Project	IEEE 802.16 Broadband Wireless Access Working Group < <a href="http://ieee802.org/16">http://ieee802.org/16</a> >	
Title	A proposal for introducing a shared RS system in MR	
Date Submitted	2006-11-07	
Source(s)	Keiichi Nakatsugawa Fujitsu Laboratories Ltd. Kamikodanaka 4-1-1, Kawasaki, 211-8588, Japan	Voice: +81-44-754-2811 Fax: +81-44-754-2786 nakatsugawa@jp.fujitsu.com
	Dorin Viorel Fujitsu Microelectronics Canada Inc. #300, 2710-17th Ave SE, Calgary, AB, T2A 0P6, Canada	Voice: +1 403 207 6311 Fax: +1 403 248 1886 dviorel@fmci.fujitsu.com
Re:	IEEE802.16j-06/027: "Call for Technical Proposals regarding IEEE802.16j"	
Abstract	This contribution proposes a shared RS system for 802.16j networks.	
Purpose	Text proposal for 802.16j Baseline Document	
Notice	This document has been prepared to assist IEEE 802.16. It is offered as a basis for discussion and is not binding on the contributing individual(s) or organization(s). The material in this document is subject to change in form and content after further study. The contributor(s) reserve(s) the right to add, amend or withdraw material contained herein.

## A proposal for introducing a shared RS system in MR

Fig. n. Example of shared RS system

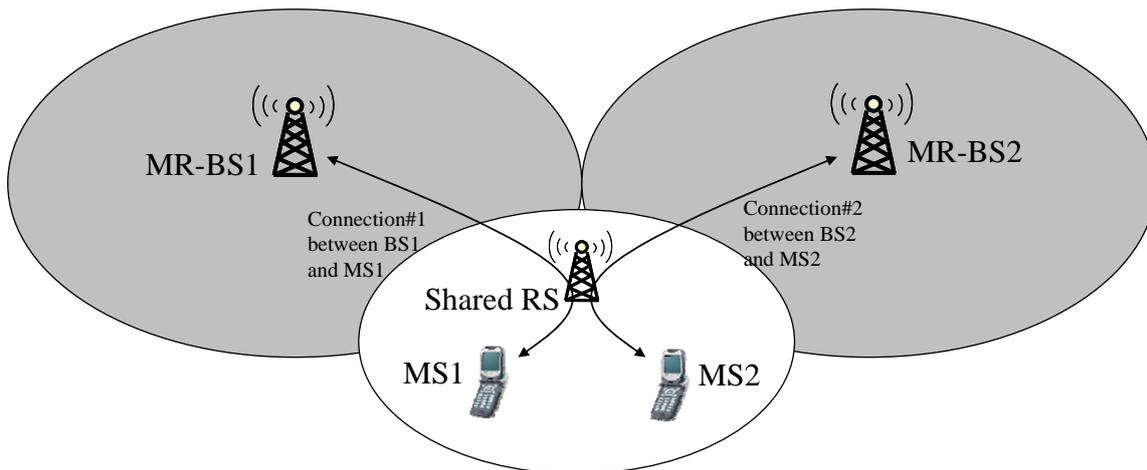
A shared RS system is defined based on the network topology example presented in Fig. n

In the shared RS system, one RS could be connected to two or more MR-BS within the same frame. Each connection from a MS is relayed to the related MR-BS by the related RS. As shown in Fig. n, connection #1 from MS1 is connected to MR-BS1 via RS. Also Connection#2 from MS2 is connected to MR-BS2 via the same RS.

Each MR-BS needs to schedule accordingly the related resource allocation without allocating the same resource simultaneously to the related RS. Each MR-BS should use different frames / zones / segments / bursts exclusively for the same shared RS without any collision.

To achieve such a resource allocation, one of the MR-BS may behave as an anchor BS and create the DL and UL-MAP on behalf of the other MR-BS, as described in 6.3.22.3. The anchor MR-BS may create the DL-MAP using Data location in another BS IE, as described in 8.4.5.3.6.
